STAFF REPORT
COMMUNITY DEVELOPMENT DEPARTMENT

HEARING DATE: 7/19/2022
TO: Mayor & City Council
FROM: Joseph Dodson, Associate Planner
208-884-5533
SUBJECT: FP-2022-0011
Briar Ridge No. 1 Subdivision
LOCATION: The site is located on the west side of Meridian Road between W. Lake Hazel Road and W. Amity Road, directly south of the mid-mile point, in the NE ¼ of the SE ¼ of Section 36, Township 3N., Range 1W.

Final Plat request for 59 single-family residential building lots (24 townhome lots and 35 detached single-family lots) and 15 common lots on 14.14 acres of land in the TN-R zoning district, by Kent Brown Planning.

B. Final Plat (date: 2/25/2022)

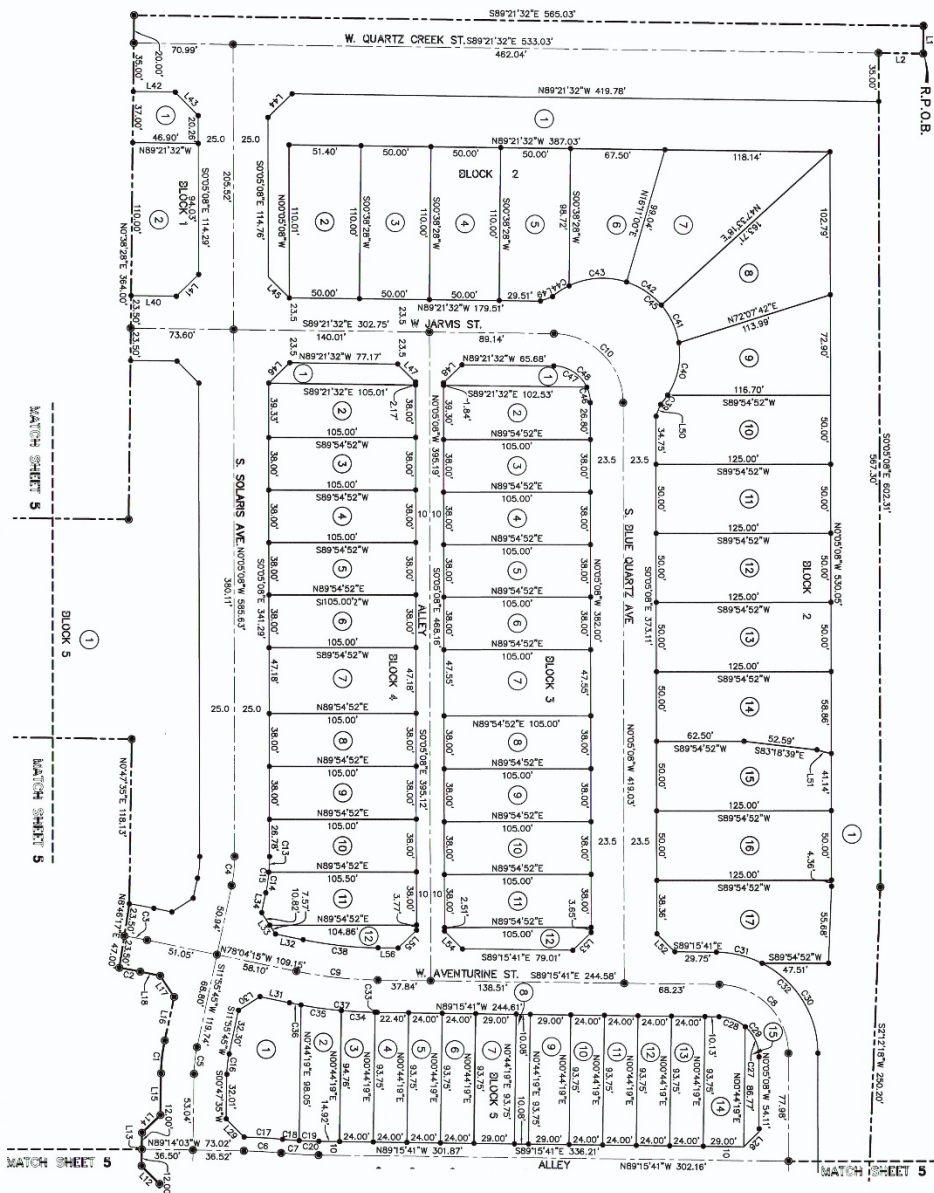
3. Prior to submittal for the City Engineer's signature, have the Certificate of Owners and the accompanying acknowledgement signed and notarized.
4. The final plat shown in Section V.B, prepared by Bailey Engineering, Inc., stamped on 02/25/22 by Cody M. McCammon, is approved with the following conditions to be completed at the time of Final Plat Signature submittal:

- a. Note #10: Include recorded instrument number.
 - b. Note #11: Include recorded instrument number.
 - c. Note #12: Include recorded instrument number.

- d. Add a plat note stating "Development is subject to all provisions contained within the recorded Development Agreement (DA Inst. #2021-161803).
 - e. Add a plat note regarding the recorded Meridian Pathway Easement and note the encumbered common lot(s).

D. Emergency Access Exhibit

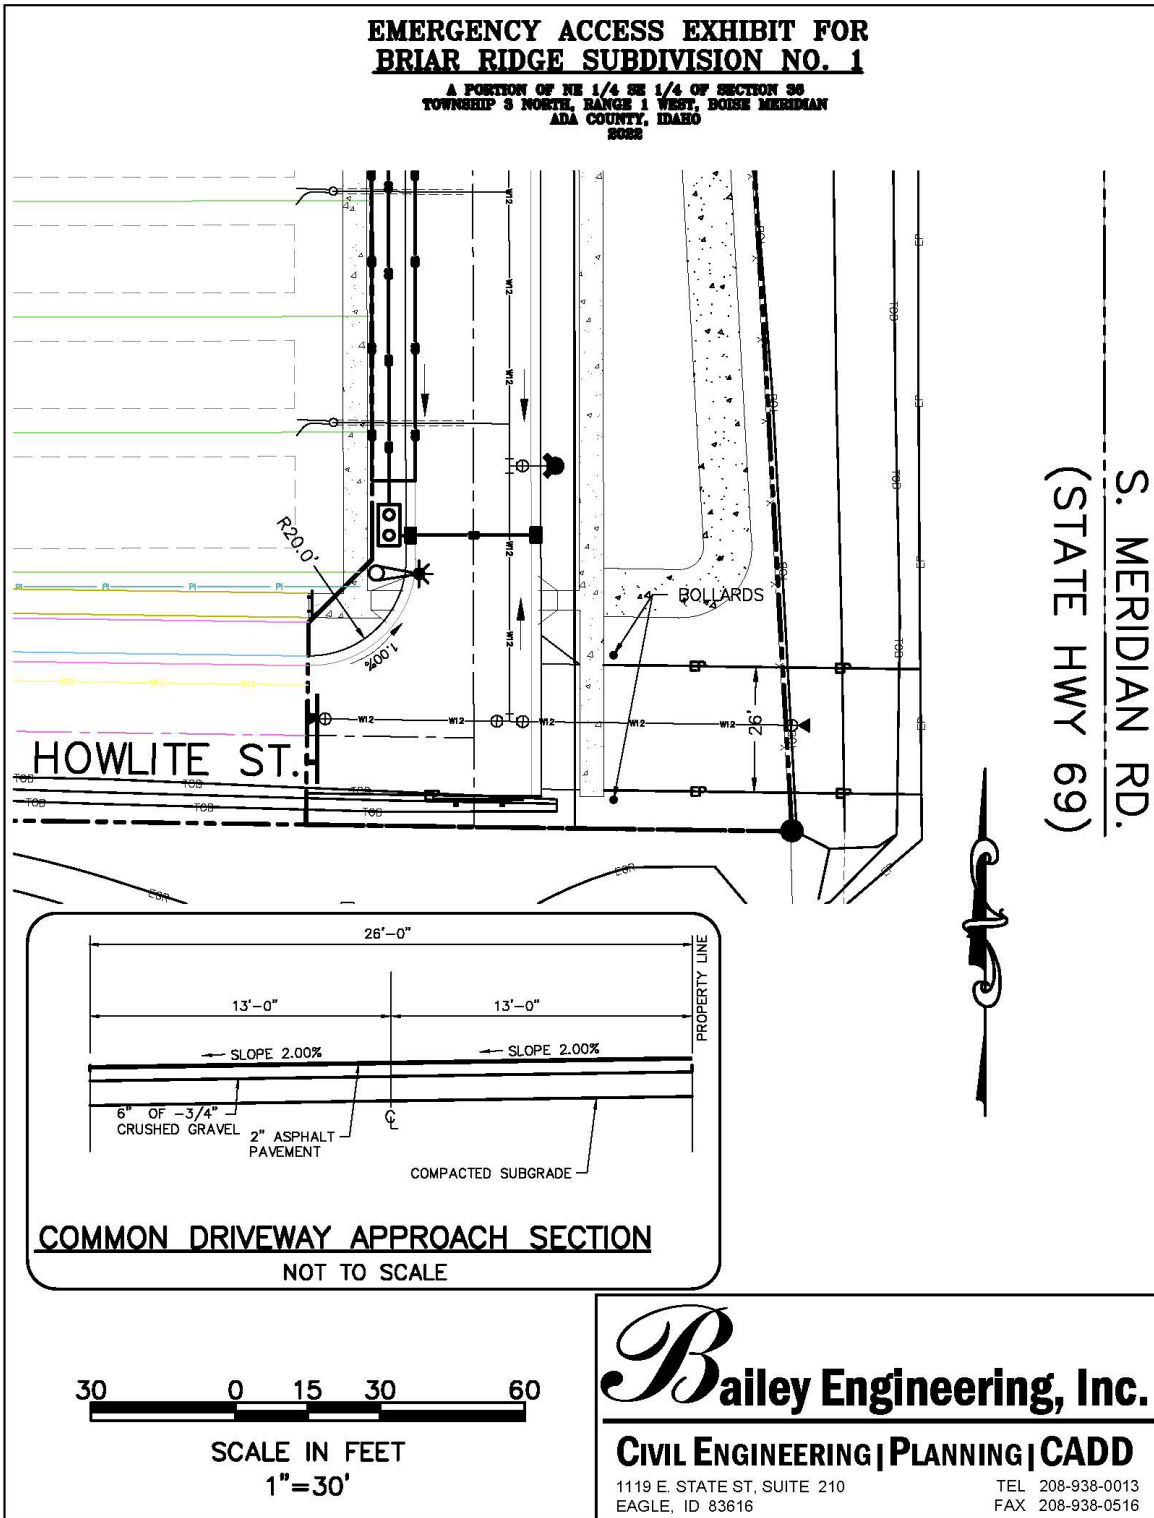
5. The Landscape Plan shown in Section V.C prepared by Bailey Engineering, Inc., dated 12/20/2021, is approved as submitted.
6. Prior to City Engineer signature on this final plat, revise the Emergency Access Exhibit (Exhibit V.D) to include enough bollards to keep the public from utilizing this access (exhibit appears to show two (2) bollards alongside the access drive but none preventing the public from utilizing access).
